Model	AD3 Finisher	Volt/Hz	Date of Modification	Serial Number
Modified Article	Parts Catalog			
Reason for Modification	Parts Catalog Correction

Model	Finisher for AD3	Volt/Hz	Date of Modification	Serial Number
Modified Article		No serial number cut-in information		
Reason for Modification	Parts catalog correction

Model: Finisher for AD3		Date: 30-Apr-97	No: 3
Modified Article: Lower Cover		Prepared by: E.Fukuyama	
From: QAC 2nd Field Information Dept.		Checked by: S. Fujii	
Reason for Modification:	<input checked="" type="checkbox"/> Parts catalog correction	<input type="checkbox"/> Vendor change	<input type="checkbox"/> To meet standards
	<input type="checkbox"/> To facilitate assembly	<input type="checkbox"/> To improve reliability	()
	<input type="checkbox"/> Part standardization	<input type="checkbox"/> Other

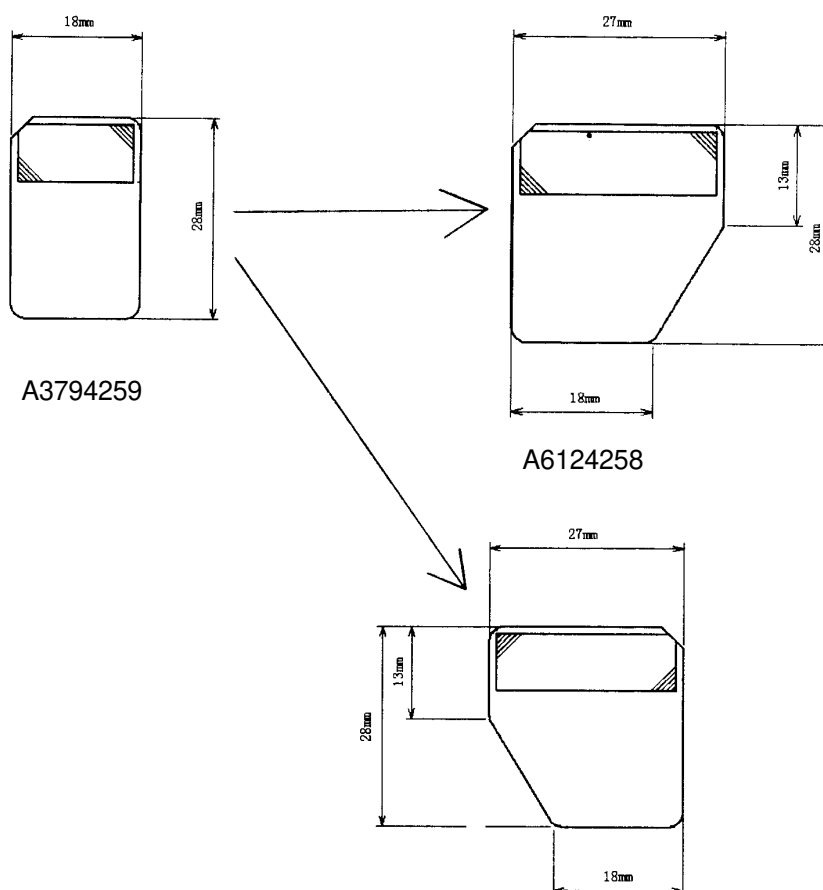
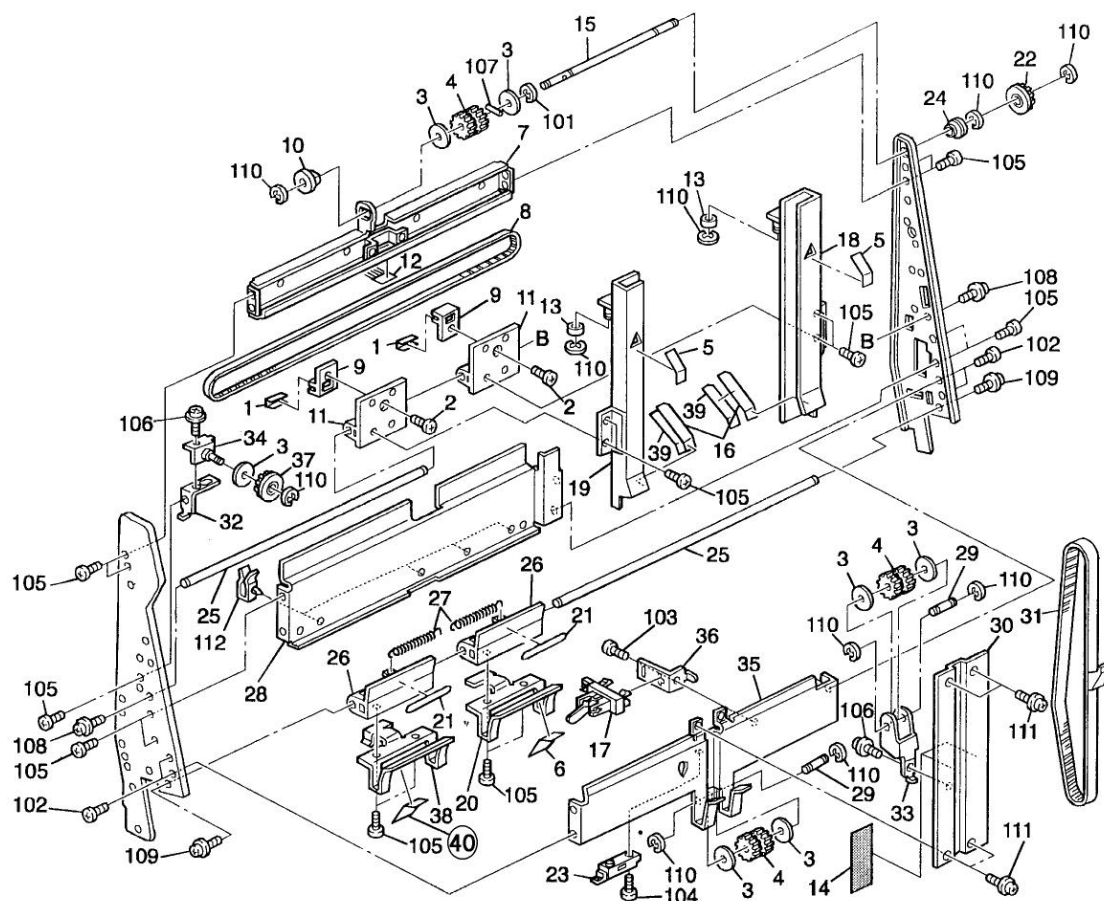
To improve paper stacking reliability, the shape of the mylar on the Positioning Fence has been changed.

Old part number	New part Number	Description	Qty	Int	Page	Index	Note
A3794259	A6124258	Positioning Fence Mylar : Rear	1	X/O	13	6	
A3794259	A6124259	Positioning Fence Mylar : Front	1	X/O	13	40

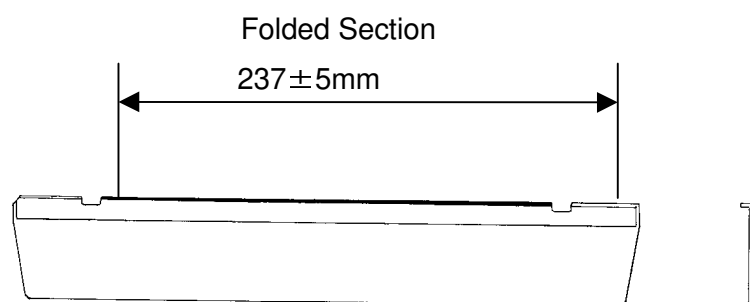
We would like to inform you of the modification to the shape of the Entrance Guide packed with the Finisher.

The Entrance Guide bends easily, so it is difficult to install on the Main Frame.

To increase the strength of the Entrance Guide (mylar), the edges have been folded.

Old Part Number	New Part Number	Description	Qty	Int	Page	Index	Note
A6122331	A6122333	Entrance Guide	1	X/O	7	19
